Focused Review of Specific Remediation Issues

An Addendum to the Remediation
System Evaluation for the
Homestake Mining Company (Grants)
Superfund Site, New Mexico
Region 6

Final Report
December 23, 2010

Prepared by US Army Corps of Engineers
Environmental and Munitions Center of Expertise
For US Environmental Protection Agency, Region 6

Figure 21.

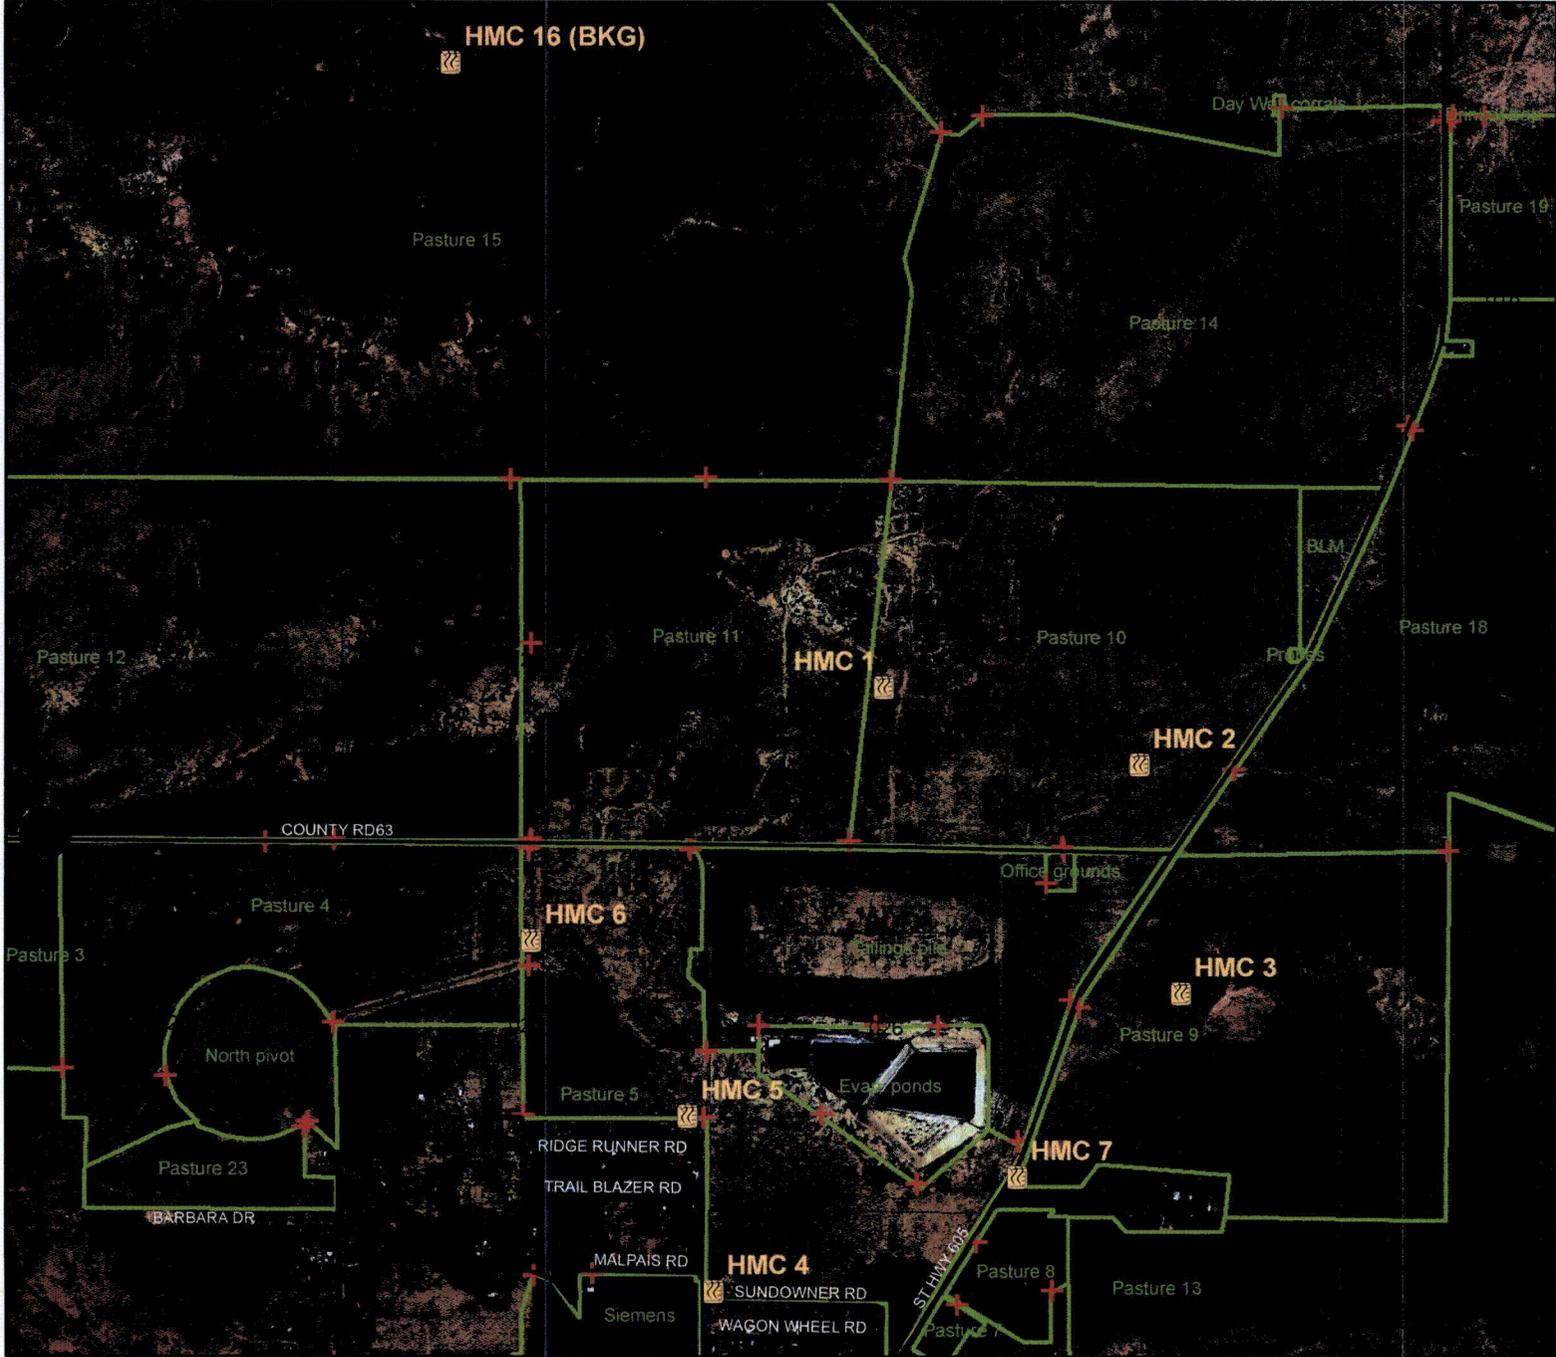
¹ DRSE Figure 21 is a copy of a map that HMC has used many reports for at least the last decade, but which is now known to be incorrect with respect to the location of HMC #16. The more recent figure that is reproduced as Figure 1 in this report not only is stated to be accurate with respect to the location of HMC #16 (see, testimony of Kenneth L. Baker, January 12, 2010 (HMC, 2010; Exhibit 36B)), but is also more legible.
